**Re: Agenda Item 4a – Comments on the Addendum to the Downtown  
Strategy 2040 Final EIR (H21-048; ER21-276; T21-043)**

We are writing on behalf of **Silicon Valley Residents for Responsible Development** (“Silicon Valley Residents”) to provide comments on the Apollo Residential Project (File Nos. H21-048; ER21-276; T21-043) (“Project”) proposed by Urban Catalyst (“Applicant”). The Project appears as Item 4a on the agenda for the November 9, 2022 City of San José (“City”) Planning Director (“Director”) hearing. The Director will consider the Project’s Initial Study/Addendum (“Addendum”), Vesting Tentative Map, and Site Development Permit (“Approvals”).

The Project proposes to demolish existing buildings on-site (totaling approximately 15,908 square feet) and construct a 20-story residential tower with up to 471 units and 7,661 square feet of ground floor retail. The building would have a maximum height of up to 198 feet and six inches to the roof. The Project site is a 1.12-gross acre site located at 32 & 60 Stockton Avenue, San Jose 95126 (Accessor’s Parcel Numbers 259-28-001 and -002).

<sup>41</sup> Addendum, Figure 3.1-1.

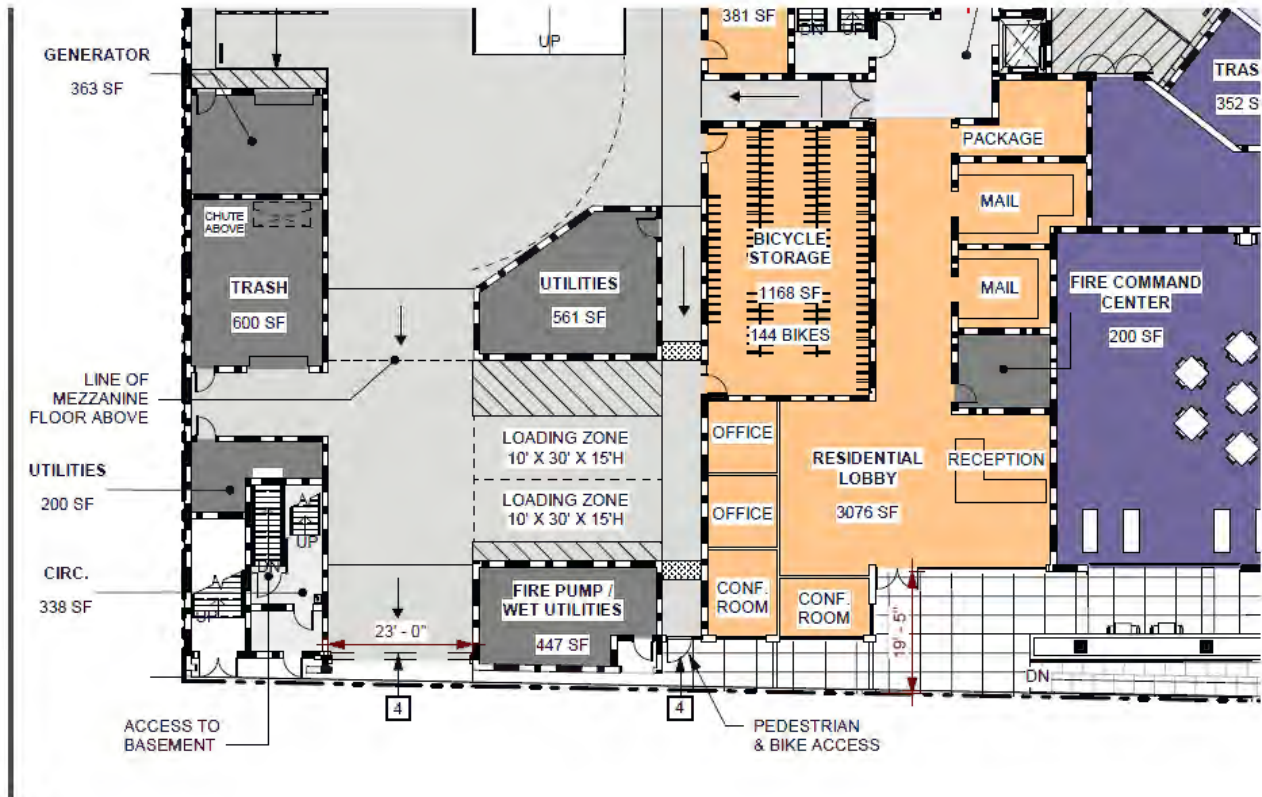
The Addendum’s project description does not include a fire pump system and emergency generator.<sup>39</sup> Dr. Clark observes that these features are not included in the City’s air quality and health risk analyses,<sup>40</sup> but that the site plan provided in the Addendum includes a fire pump system and generator:<sup>41</sup>

Figure 3: DISC Conceptual Transit Boundary with subject property highlighted. Adapted from Diridon Station Joint Policy Advisory Board meeting presentation, April 23, 2021.

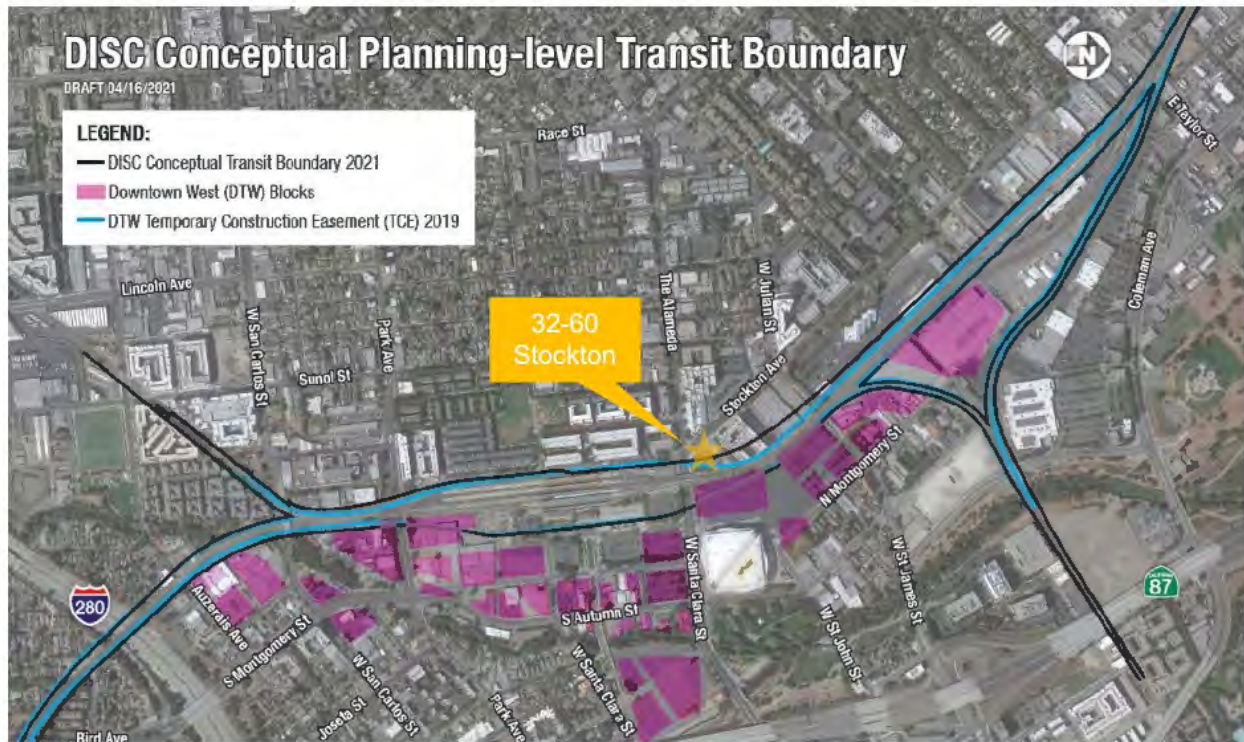
The DOT memorandum explains that the track approaching into the future expanded Diridon Station would encroach onto the Project site.<sup>71</sup> As a result, the current development of the Project site conflicts with the DSAP – a program, plan, ordinance, or policy addressing the circulation system, including transit, roadways, bicycle lanes, and pedestrian facilities.

The Project’s inconsistency with the DISC is a significant impact under CEQA. The Project would interfere with the tracks running from the north side of the expanded Diridon Integrated Station.<sup>74</sup> This inconsistency must be resolved in an SEIR.
